Ref: KPCIP/CIU-ATD/CE/078

PROJECT: Construction of WATER TREATMENT PLANT (CW2- Lot 2 - KPCIP Abbottabad)

SUBJECT: Observations Reported by CIU Engineer 20-03-2024

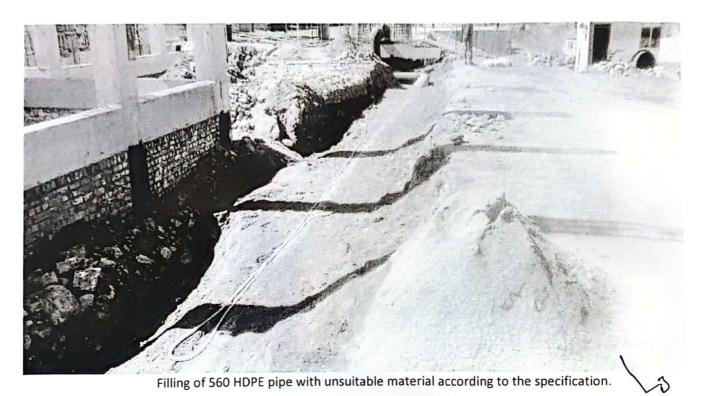
Back filling of left side plum concrete retaining wall not according to the specification

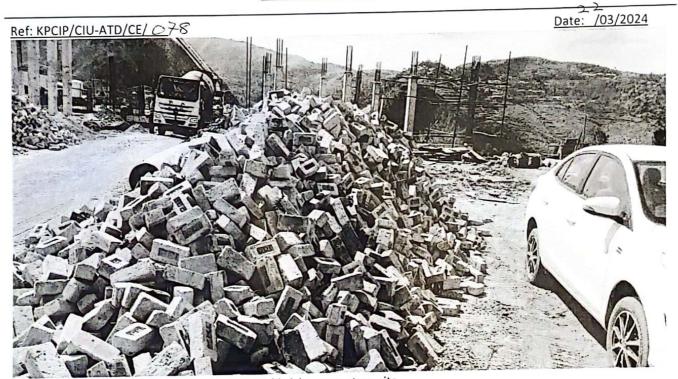
Rejected bricks present on site

Rebar is lying in open air without proper warehousing making rebars rusted.
